**ADDENDUM NO. 3**

**March 04, 2025**

**RE: Pendleton County Fire Station  
2663 HWY US 27 N.  
Falmouth, Kentucky 41040  
Project No. 24056**

**FROM: Brandstetter Carroll Inc.  
2360 Chauvin Drive  
Lexington, Kentucky 40517  
Phone 859-268-1933  
Fax 859-268-3341**

**C-102**

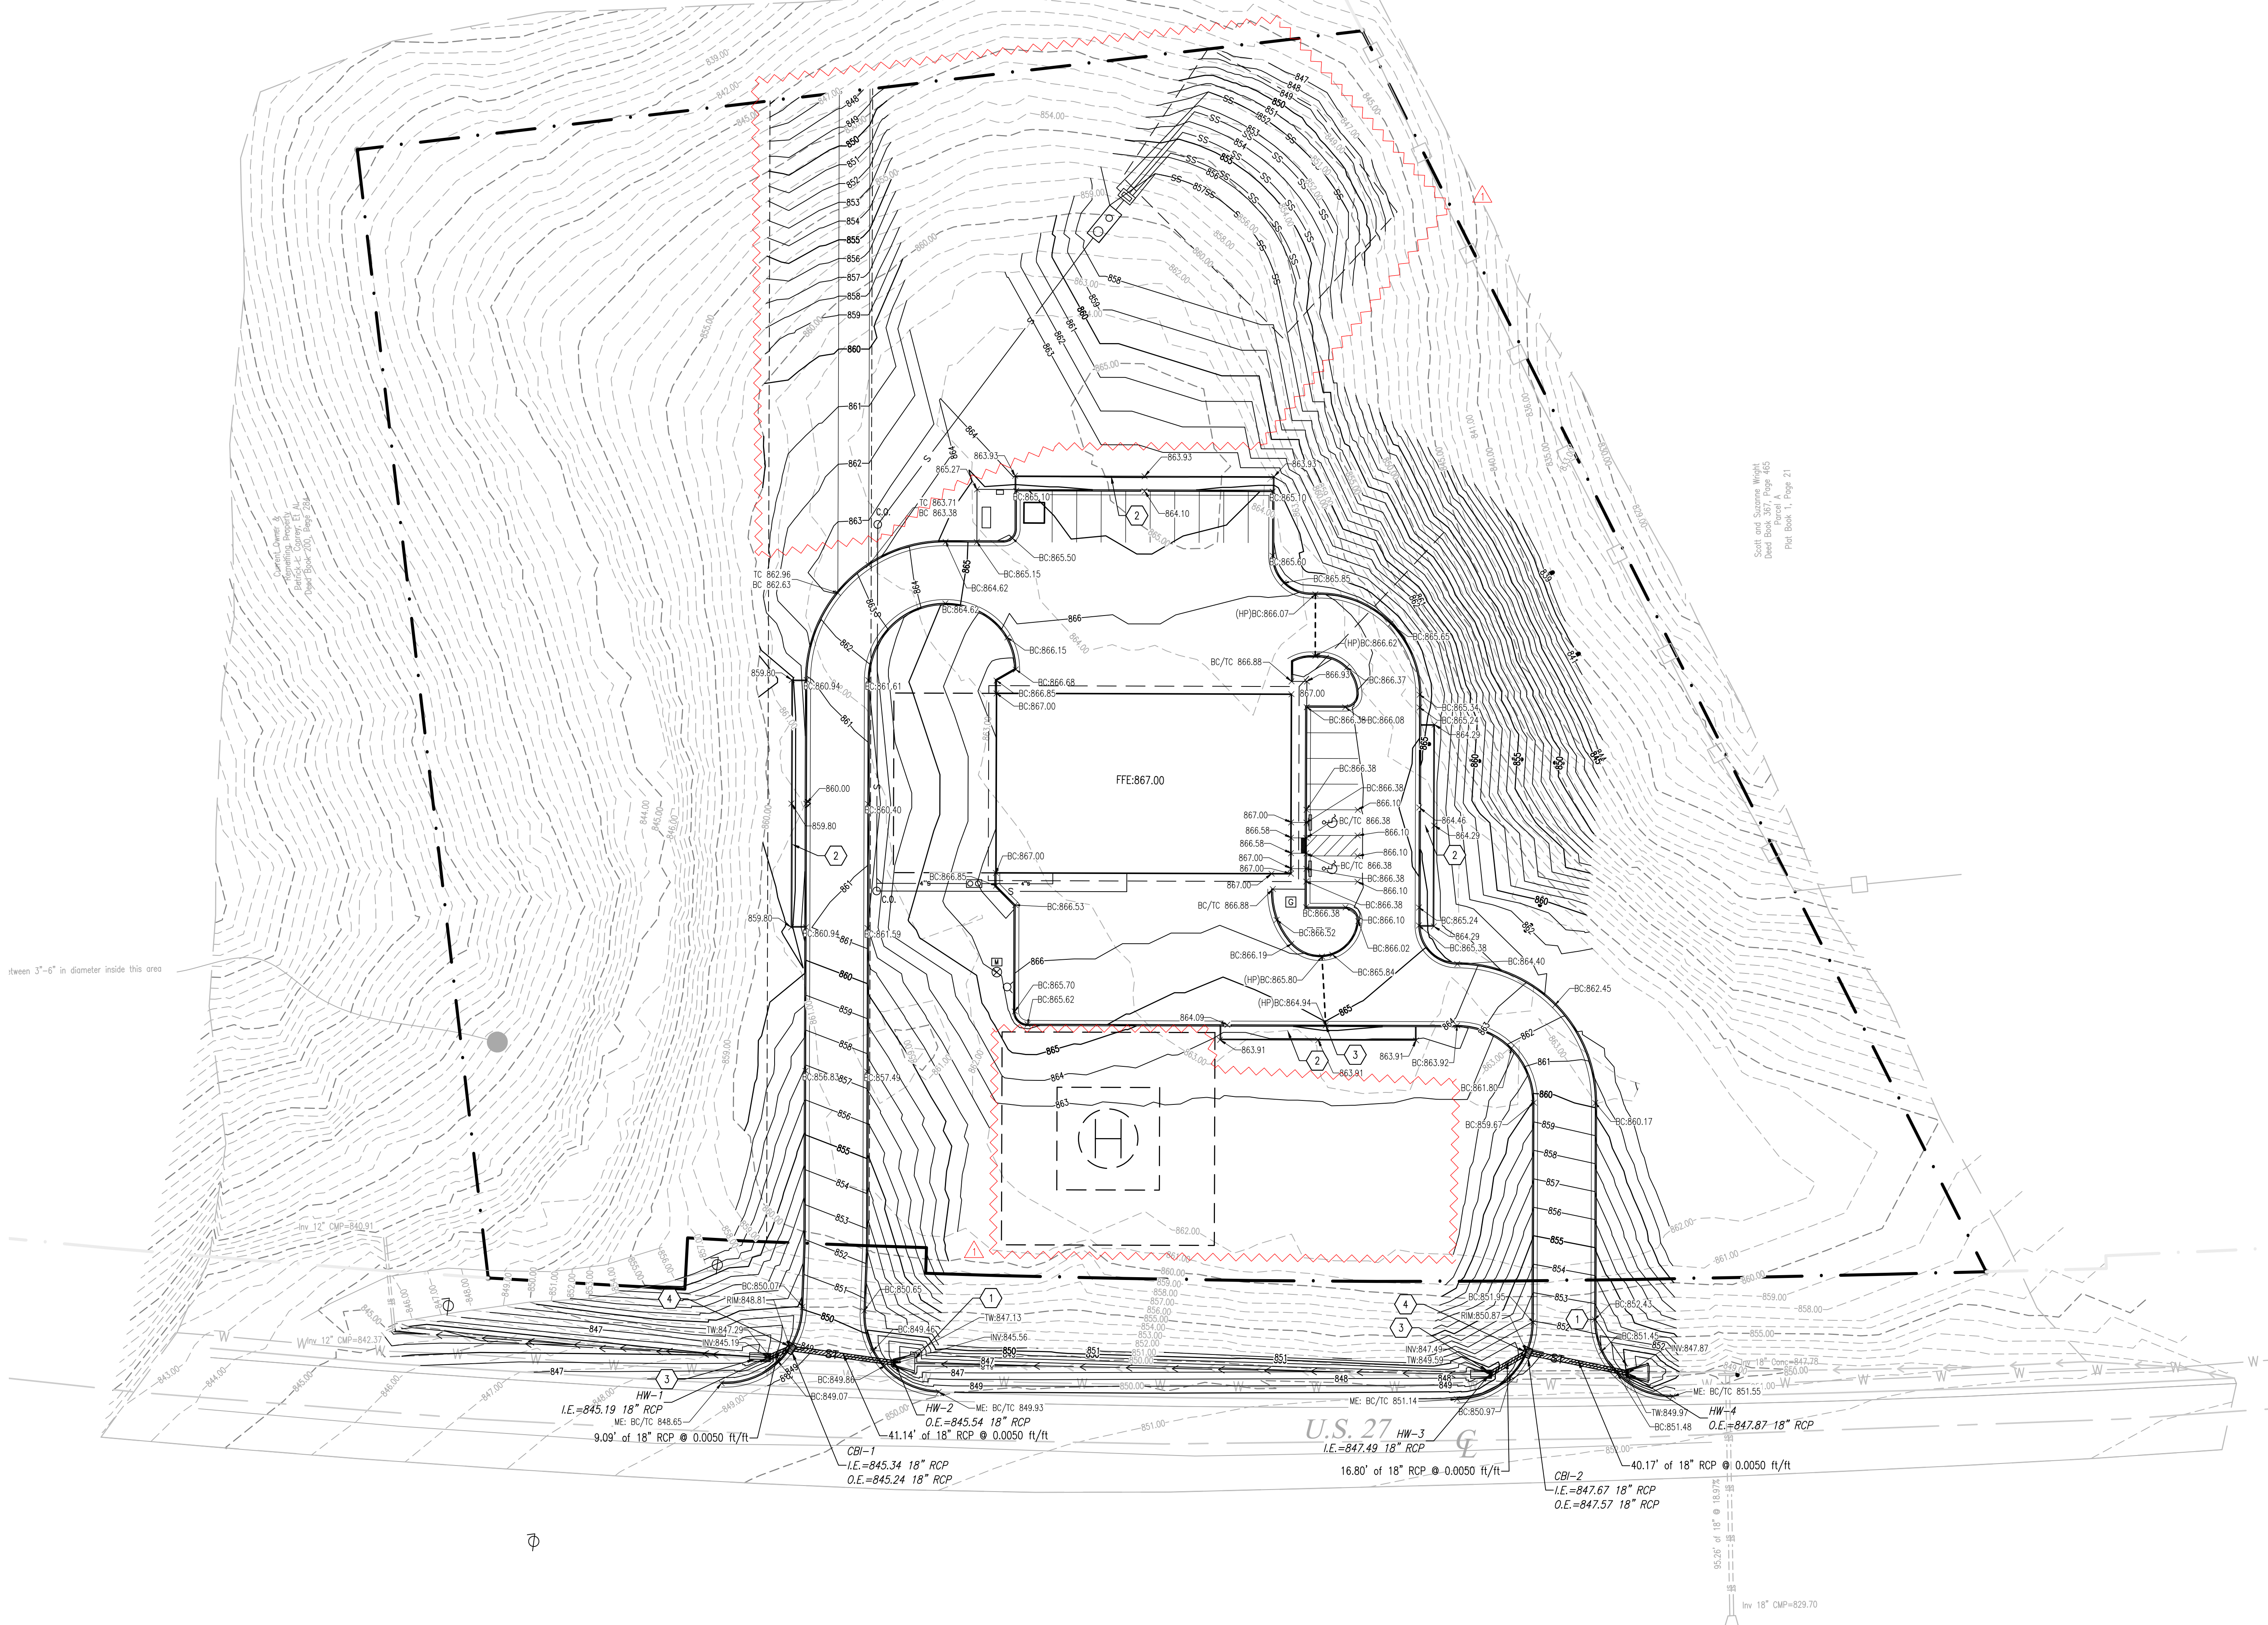
1. Sheet C-101 SWPP:
  - a. Adjusted silt fence.
2. Sheet C-102 Layout and Materials:
  - a. Adjusted helipad location.
3. Sheet C-103 Dimensional Plan:
  - a. Adjusted helipad location.
4. Sheet C-104 Grading and Dimensional Plan:
  - a. Adjusted helipad, grading, and the septic field locations.
5. Sheet C-105 Utility Plan:

C-105

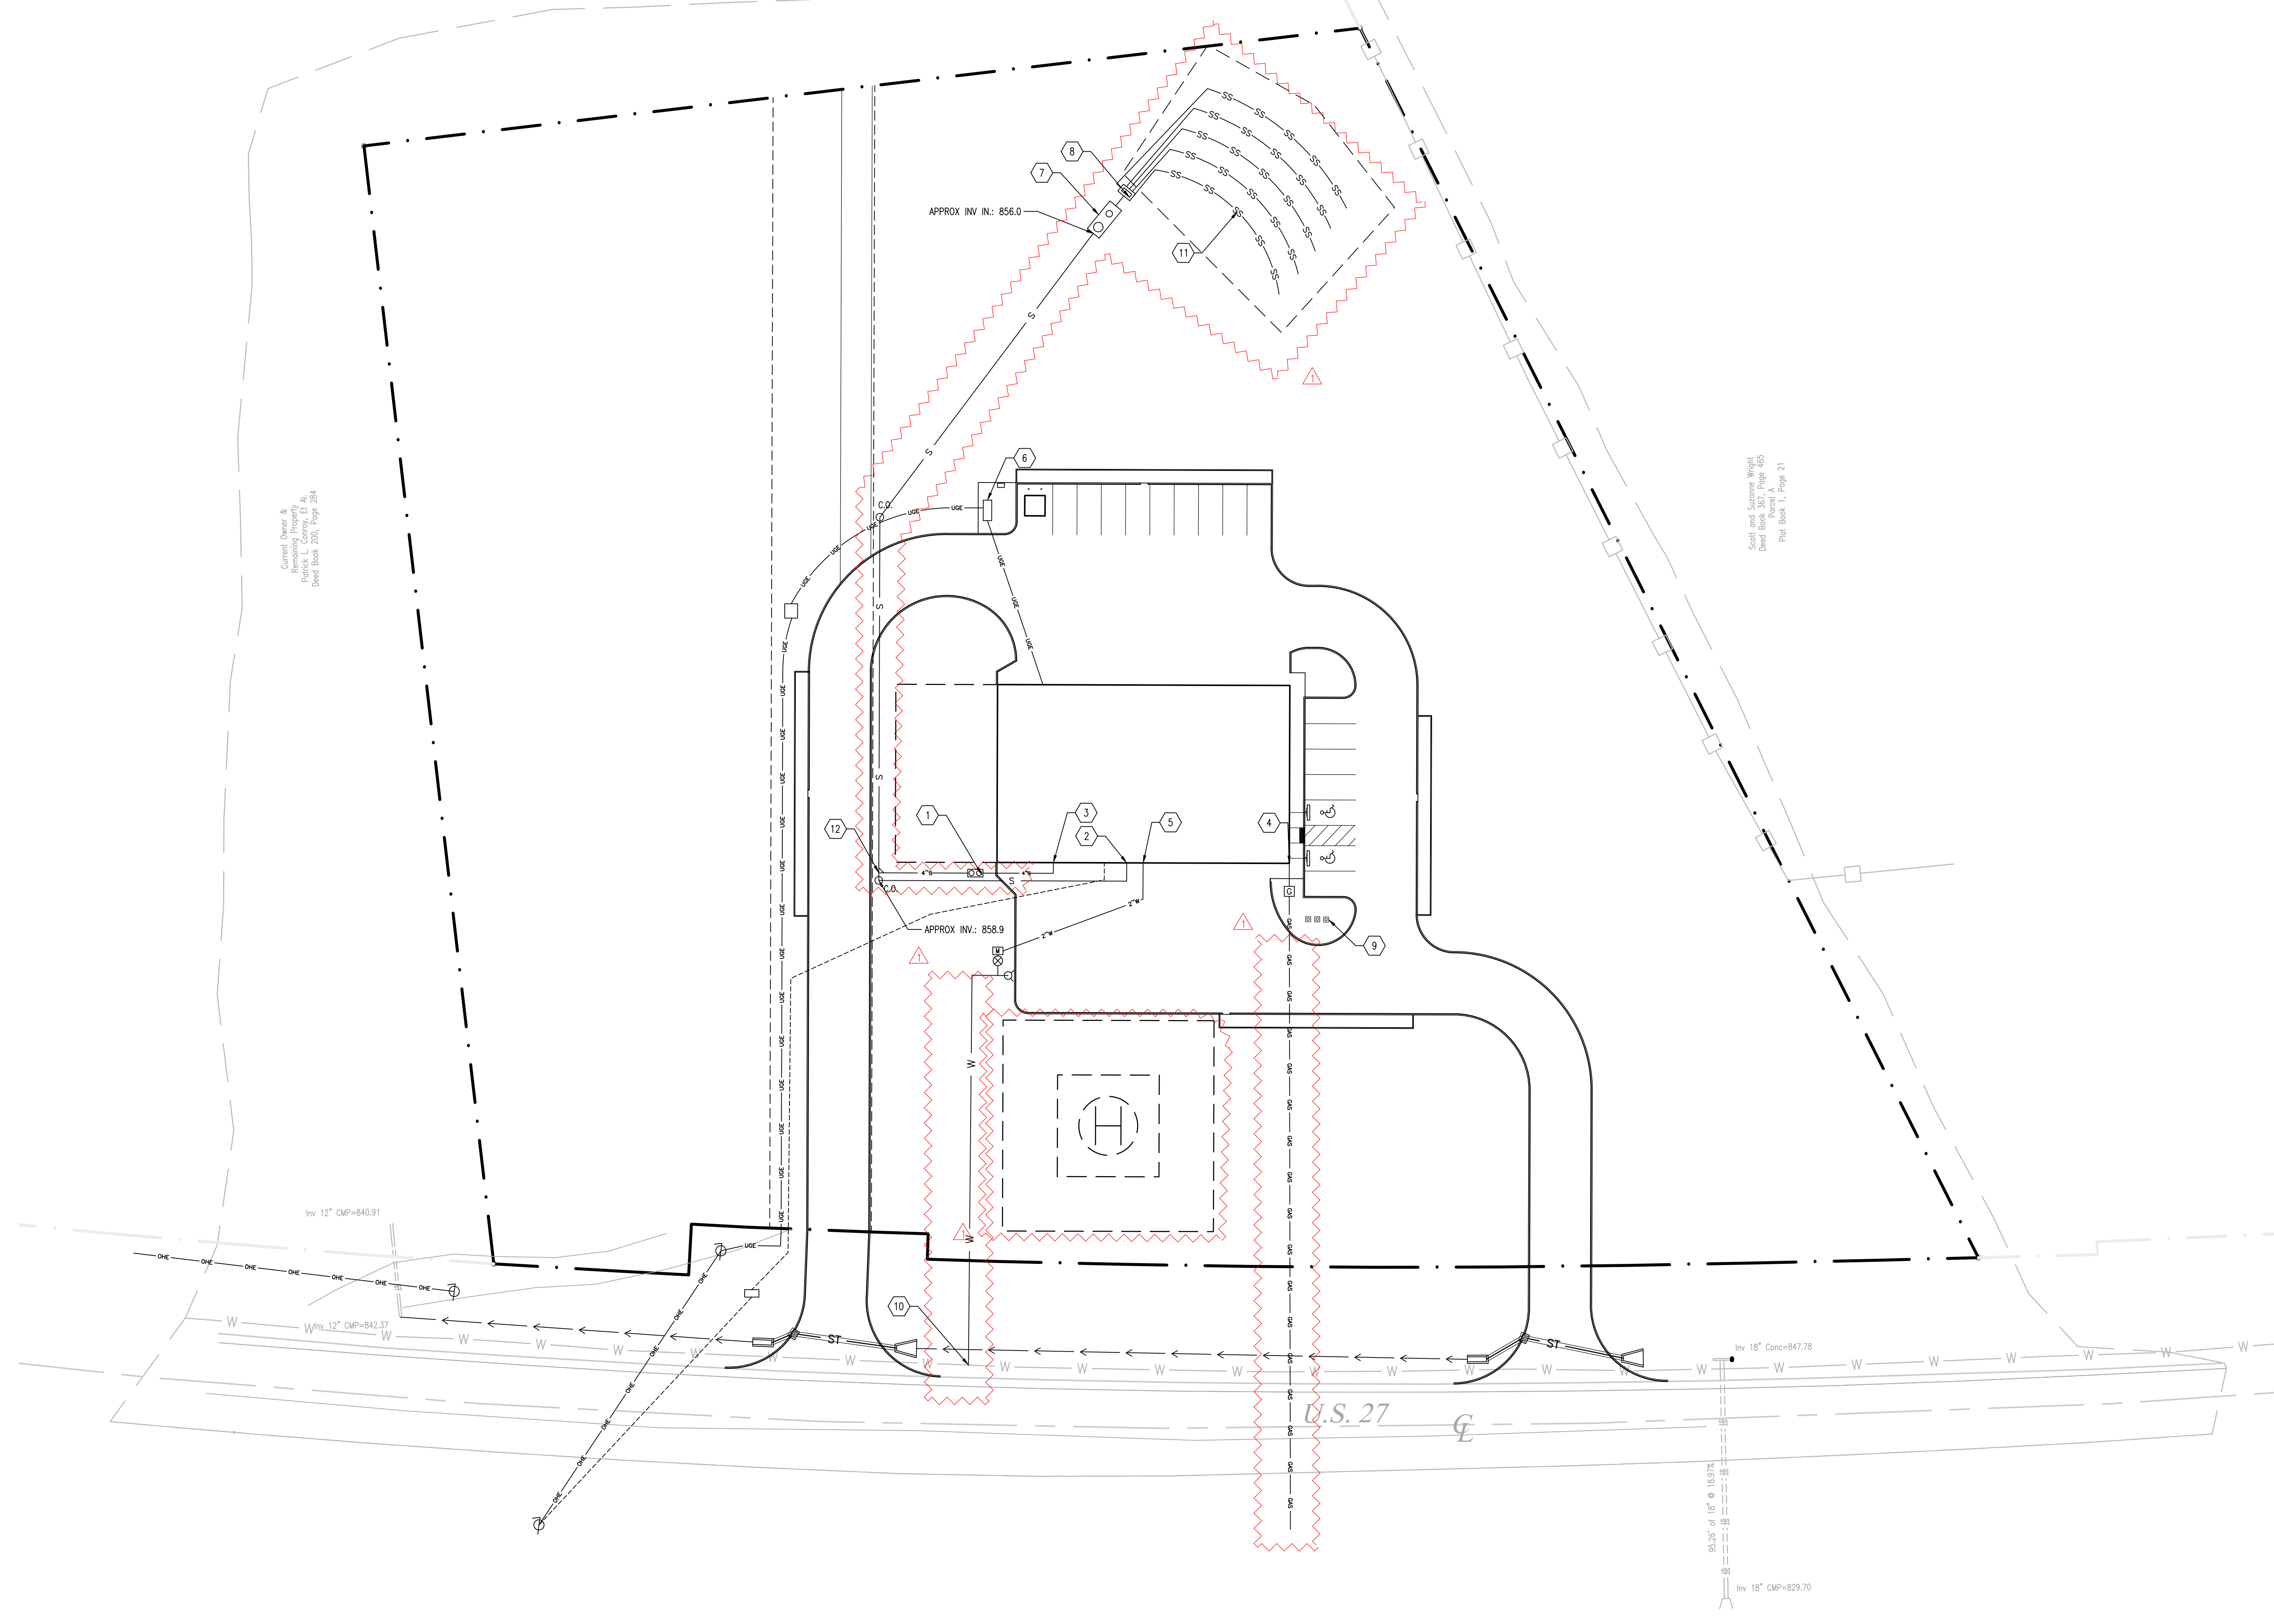
- a. Adjusted helipad and septic field locations.
  - b. Updated legend and coded notes.
  - c. Revised sanitary, gas and water.
- 6. Sheet C-201 Road Profiles:
  - a. Revised sanitary line.
- 7. Sheet C-501 Site Details:
  - a. Revised the printing scale only for both headwall details.
- 8. Sheet E100 Site Electrical Plan:
  - a. Revised conduits for future monument sign and to the Helipad.
- 9. Sheet E501 Site Electrical Schedules:
  - a. Revised light fixture schedule.
